# Safety Evaluation Report

related to the operation of  
Limerick Generating Station,  
Units 1 and 2

Docket Nos. 50-352 and 50-353

October 1984

FIGURE 1

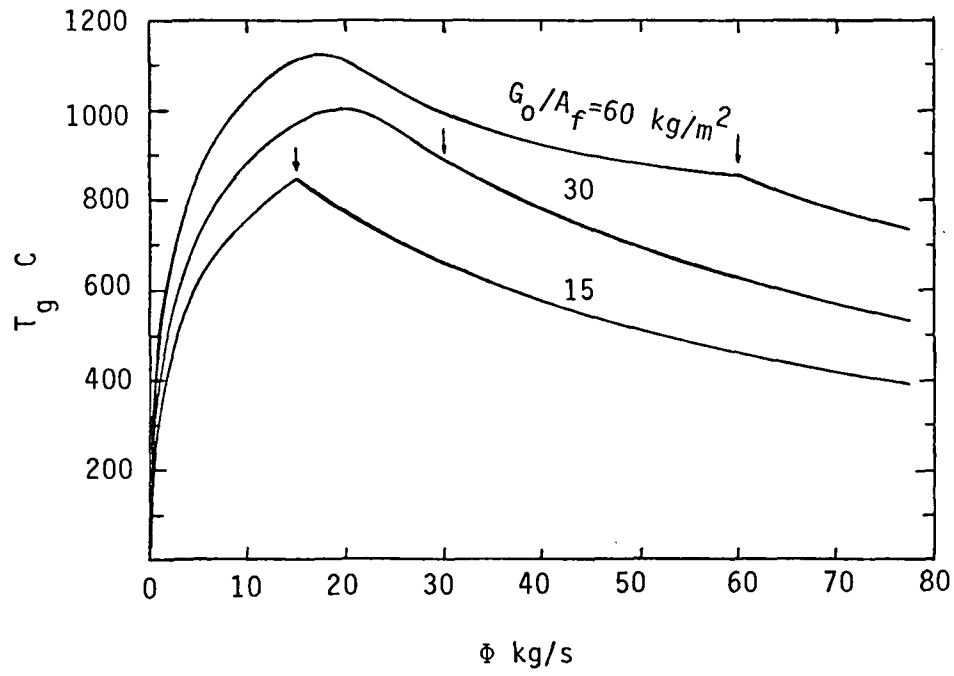
The above result may appear to contradict the discussion in Reference (11). This can be explained by two factors. First, Reference (11) does not consider a constant heat flux for the duration of the fire as assumed in the submittal and second, the level of ventilation is important. Consider Figure 1, which is a reproduction of Figure 8 of Reference (11). For low ventilated fires

the gas temperature does increase with increased ventilation reaching a maximum at values near or greater than the ventilation limit (indicated by the arrows) which depends on the fuel loading. Use could be made of the fact that the maximum temperatures occur at about the same value of ventilation parameter, independent of fuel load, to determine the most severe scenario in a fire area. Figure 8.4 of Reference (13) also illustrates examples of increasing gas temperatures with increased ventilation in ventilation controlled fires.
